Addendum 2: DSU Medgar Evers Hall Renovation Contract: 2012-PC-003-EH

1. Bid RFI Questions & Answers

| Evers Hall Renovation 2012-PC-003-EH | | |

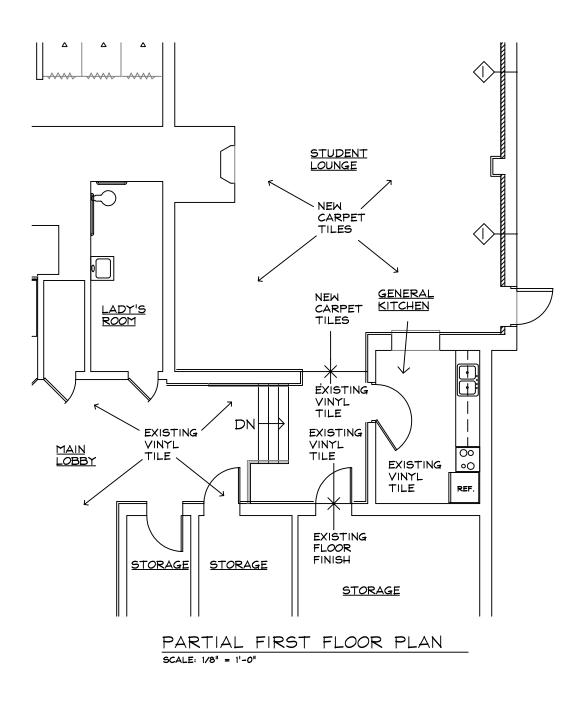
| SU Lydia Laws Hall Renovation | 4/5/2012 |
|--|--|
| Q28. Reference drawing D2 Student Lounge Demolition Note #1; How much existing damaged, | A28. See A6 above. |
